## ADDENDUM NO. 2

DATE: October 23, 2013

Contract 14-C-00003; Downtown Gateway Lighting Improvements – Sheltered Market

**IRRIGATION PLAN**  
**ORANGE - TYLER INTERSECTION**  
**ORANGE AVE AT CASS & TYLER STREETS**  
**IRRIGATION PLAN**

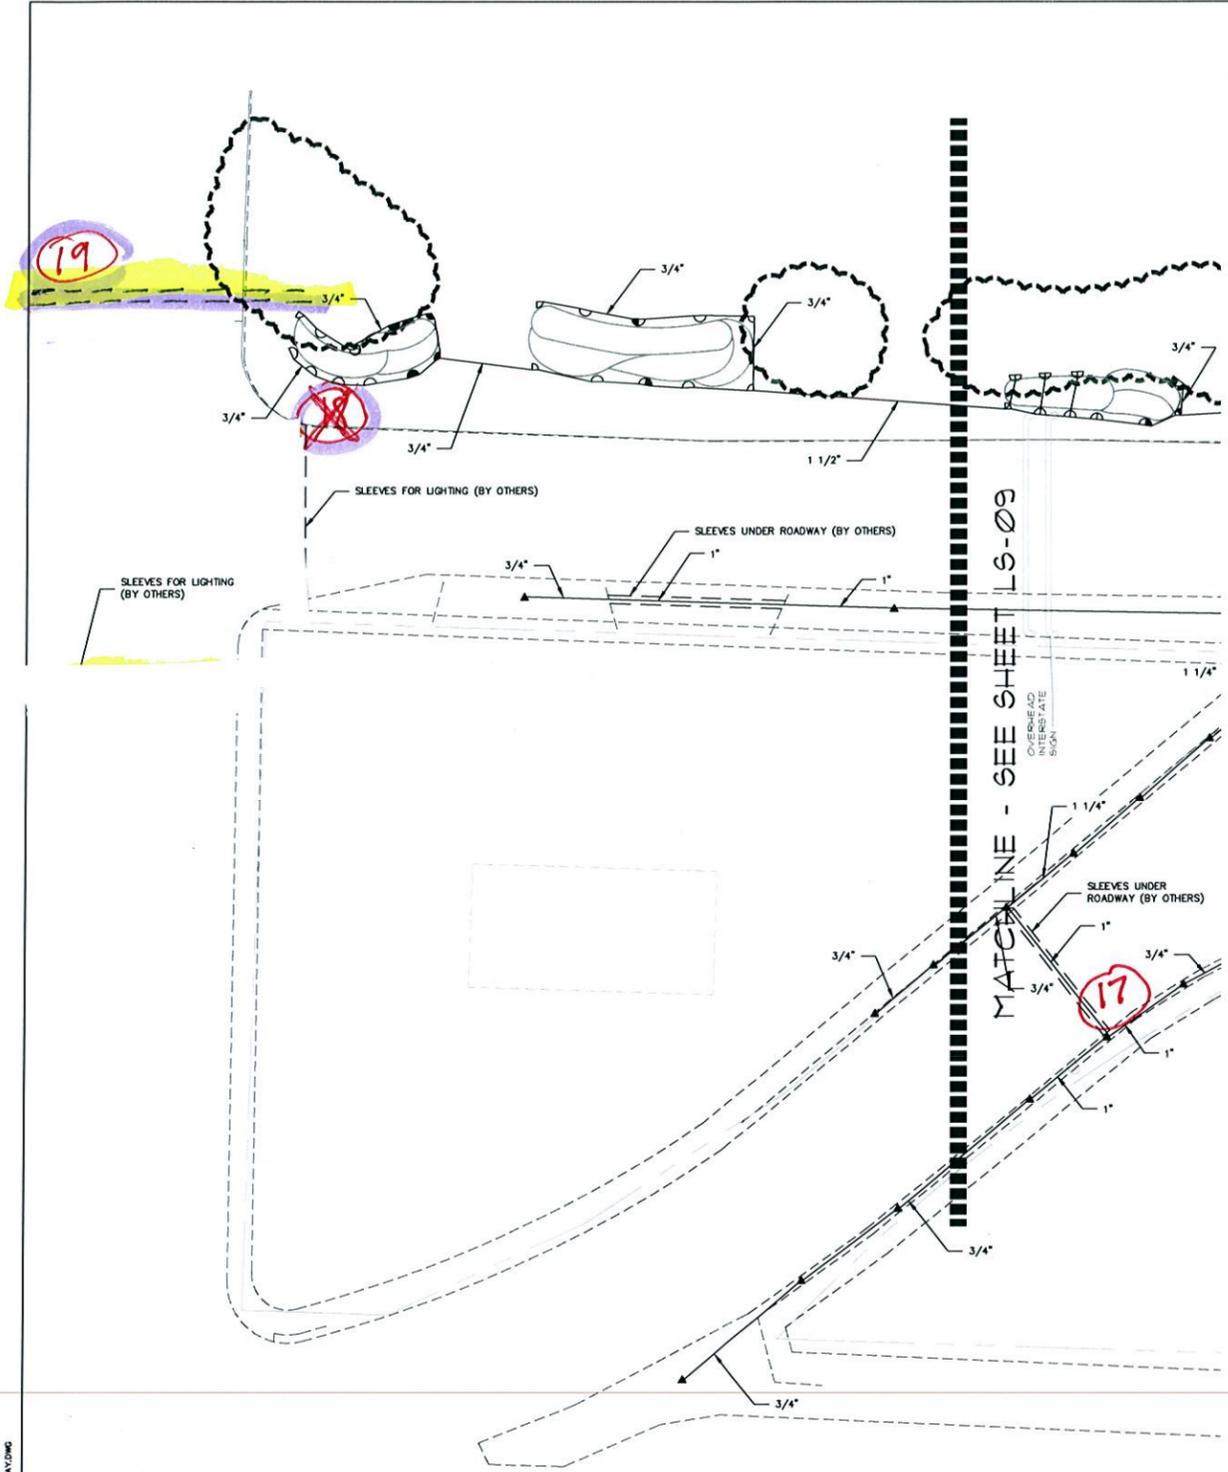
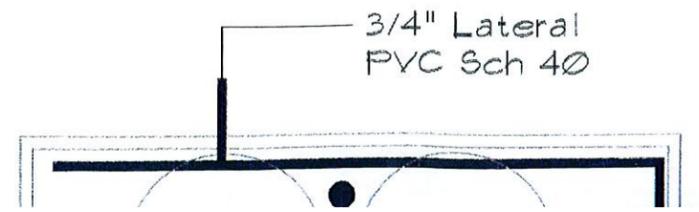
City of Tampa to replace existing controller with IRRInet-M 24-AC Controller

COT P4R to add double check valve

Specialized Area Layout for planting areas with existing trees:  
(4) 1/2 gallon bubblers to water groundcover. To minimize damage to existing tree roots, run bubblers on 1/2" flex pipe on top of ground under mulch to desired locations.

Area B Layout  
(6) 1/2 gallon bubblers to flood area of new groundcover

Area B Layout  
(7) 1/2 gallon bubblers to flood area for trees and groundcover

Area B Layout  
(12) 1/2 gallon bubblers spaced to water groundcover and new trees
